APPLICATION FOR HISTORIC AREA WORK PERMIT

MONTGOMERY COUNTY HISTORIC PRESERVATION COMMISSION

LOCAL ADVISORY COMMITTEE REVIEW FORM

c. Address of Property: 7205 Cedar Avenue

FRONT VIEW OF
REAR PORCH

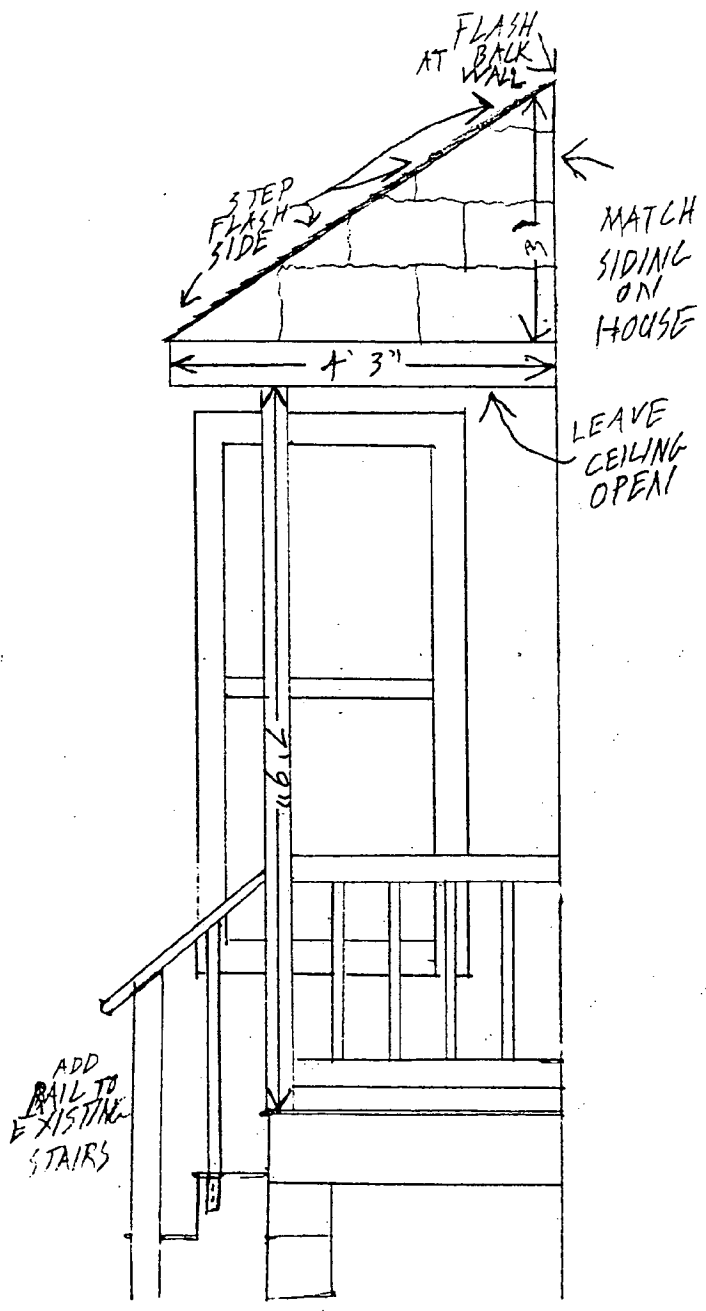
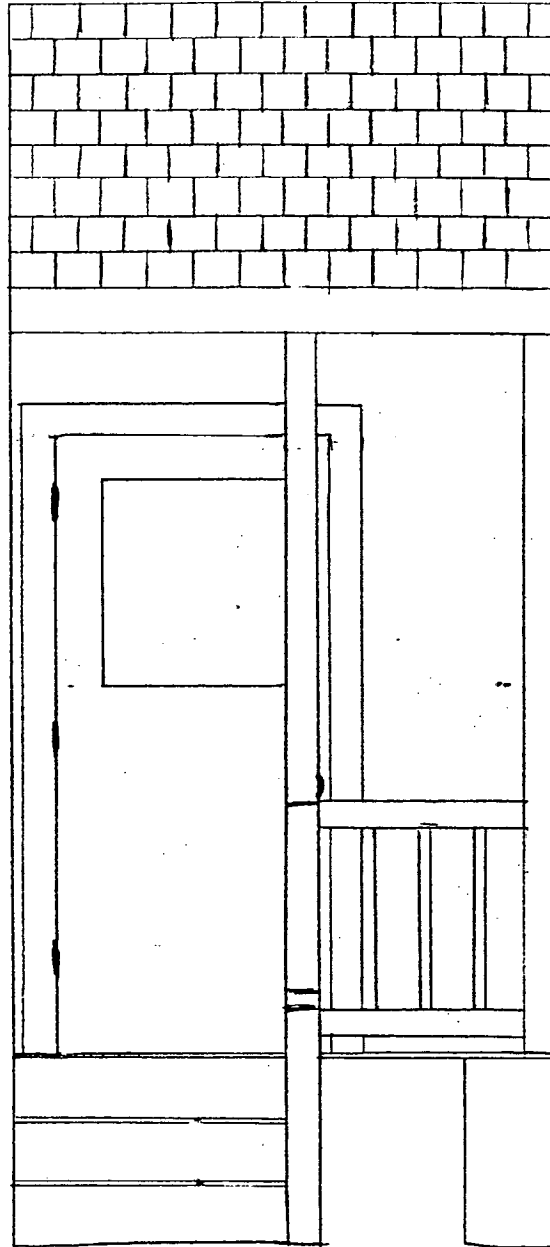
None - this is minimal alteration, consistent with house design, needed to protect entrance. Work is restricted to private yard--no impact.

See III.2. No impact
